F	5.11.24	Council RFI
E	14.3.24	Final issue
D	12.3.24	For Review
C	21.2.24

LANDSCAPE
PO Box 4050, ACT 2602
ABN: 16 949 100 279
Phone: 02 9907 8011
www.scrivener-design.com
Email: paul@scrivener-design.com
Project: New development @
54-68 Hampstead Road &
276-282 Parramatta Road,
Auburn

Dwg: Landscape plan - Ground floor /

Issue - F Amendments clouded red

Dwg: Planting / Details plan

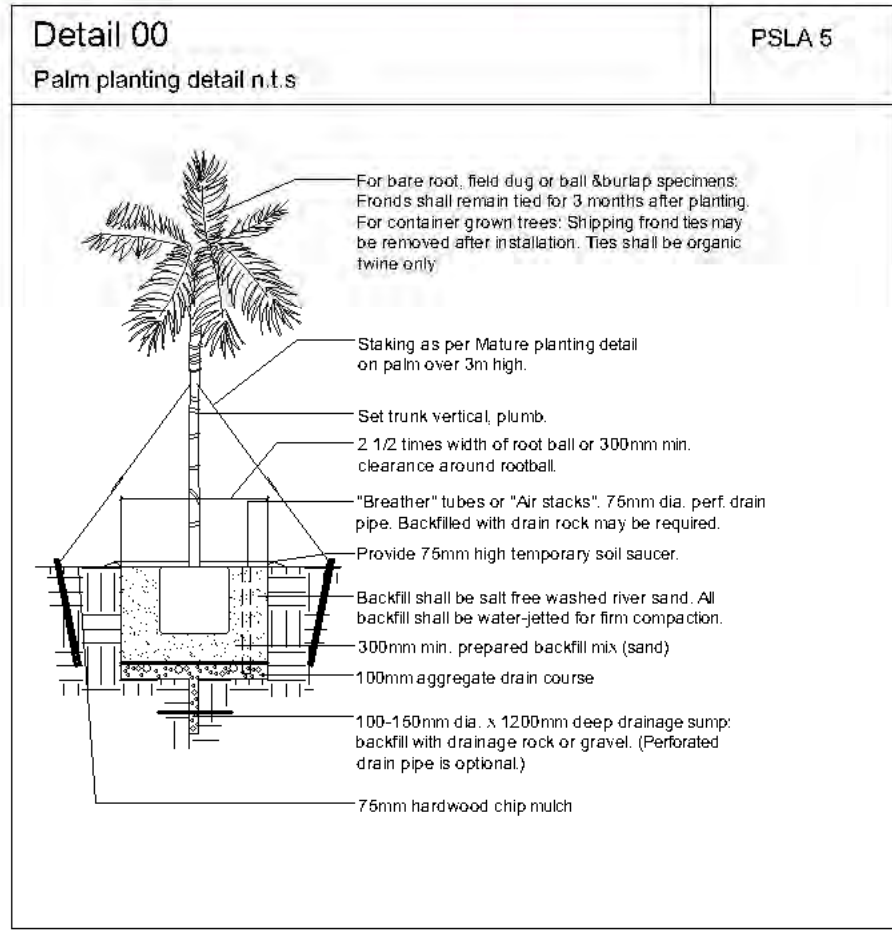
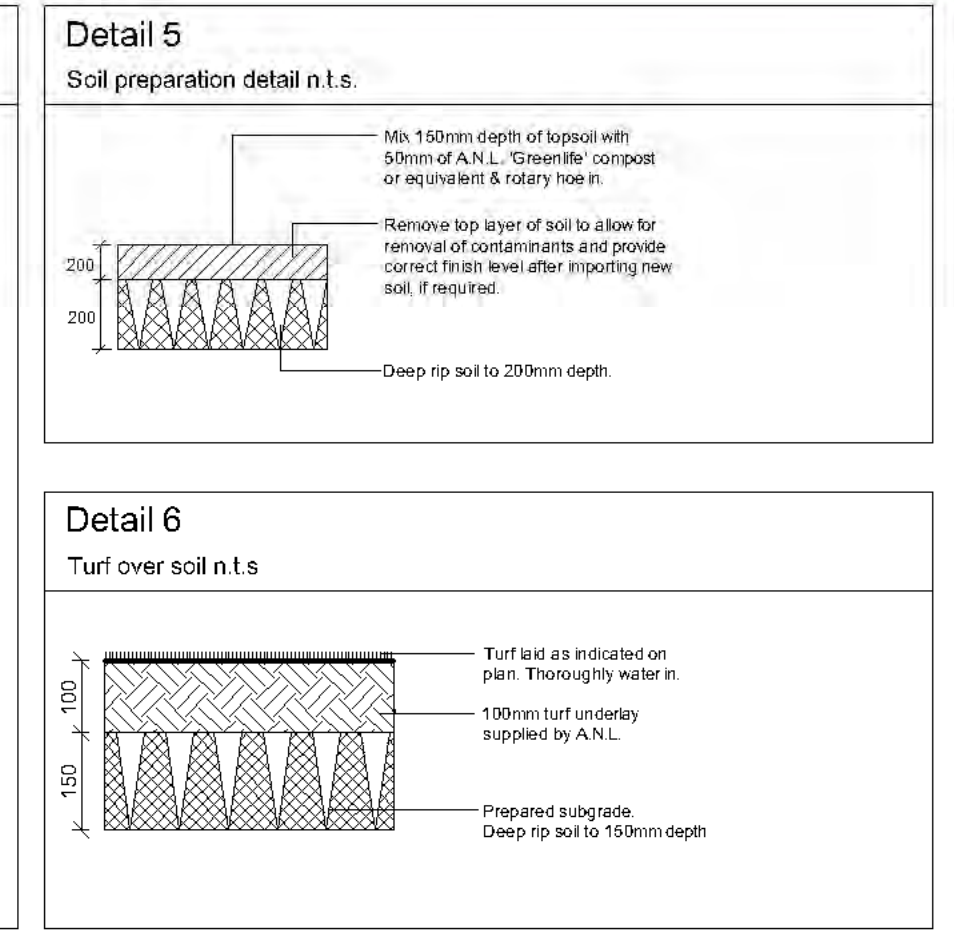
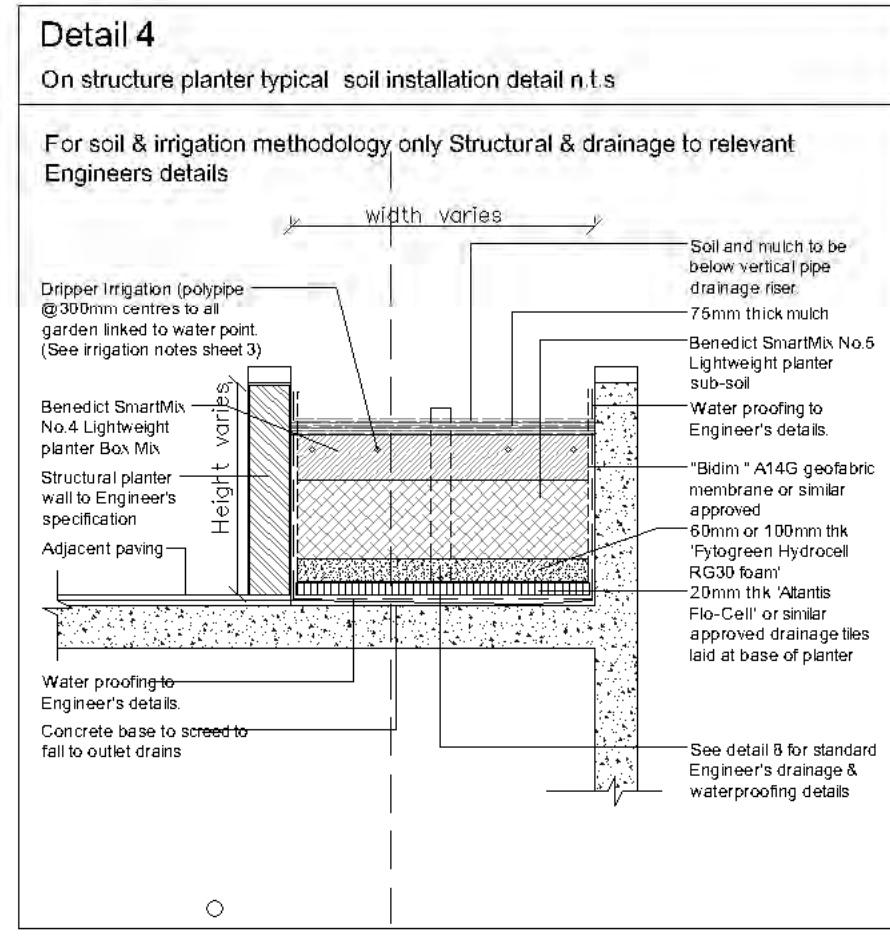
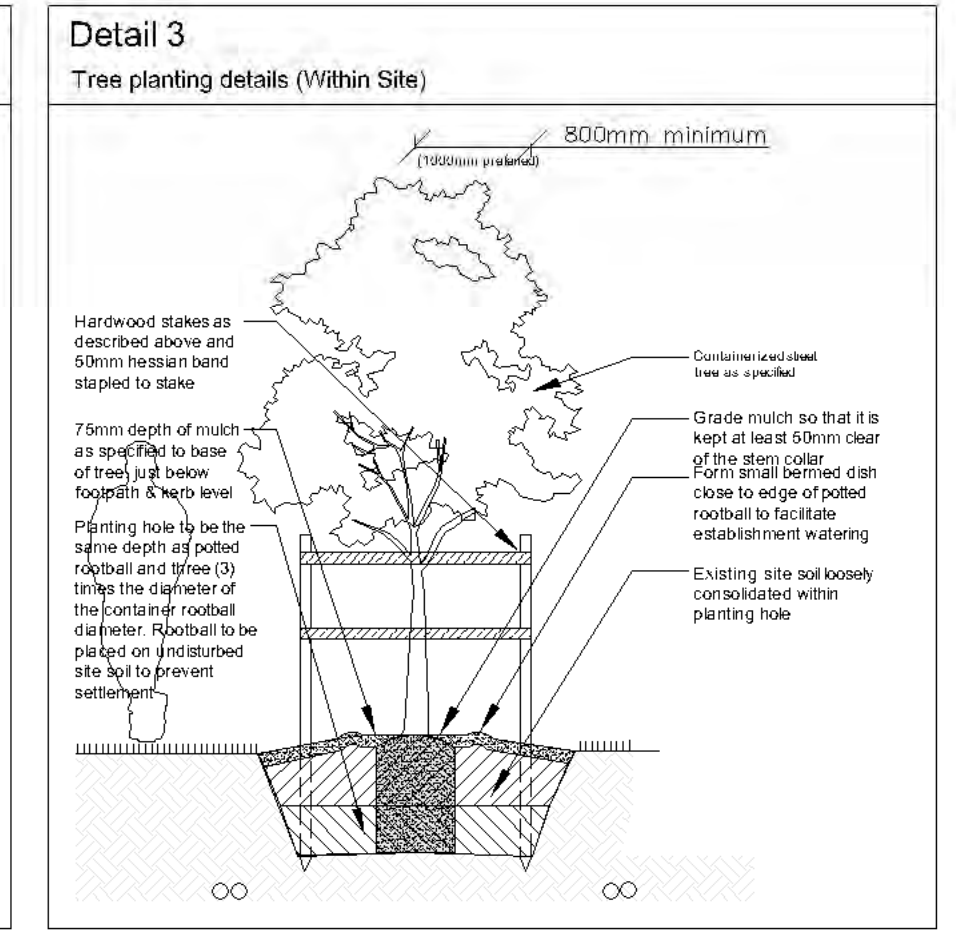
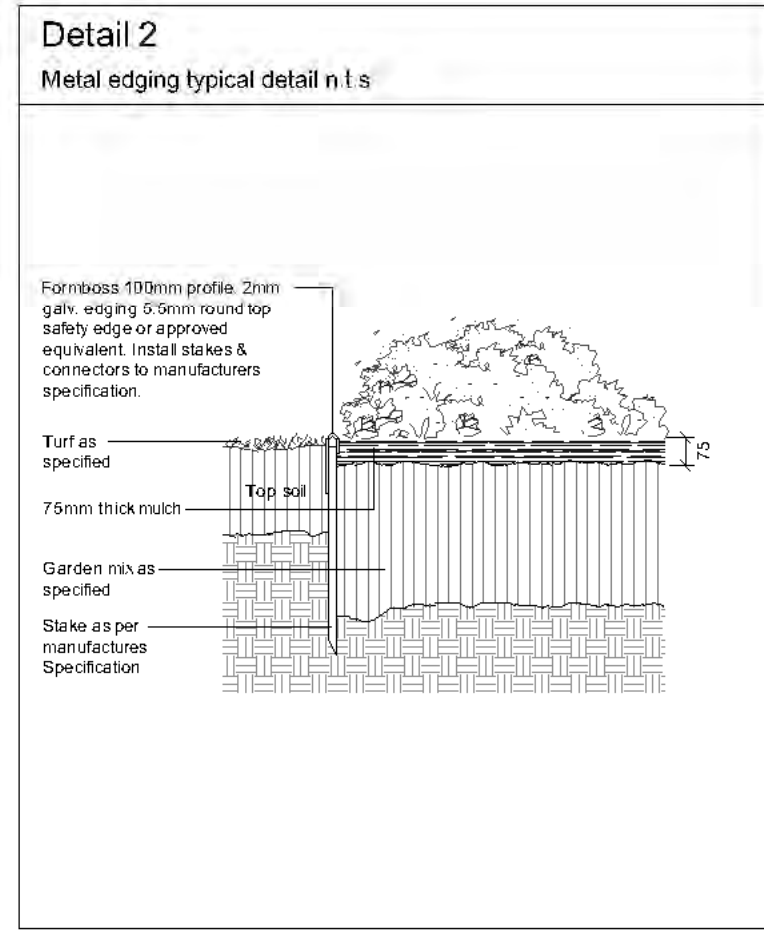
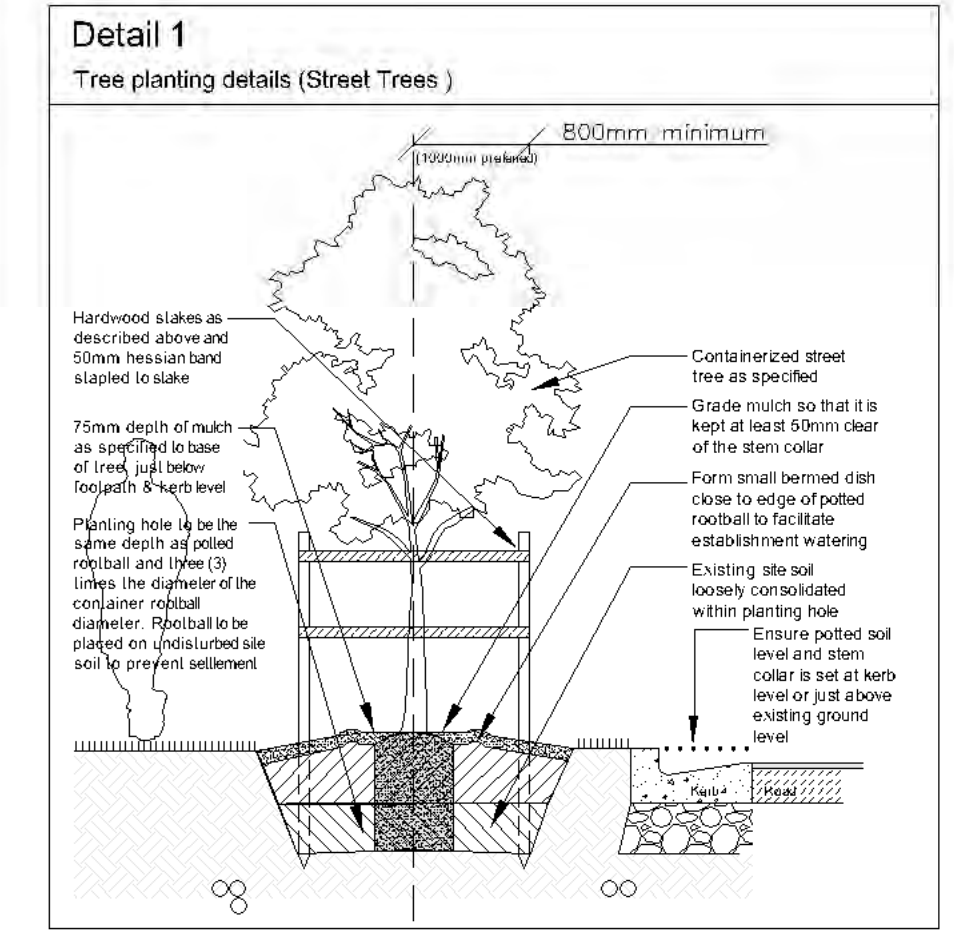
Trees relocated further into deep soil
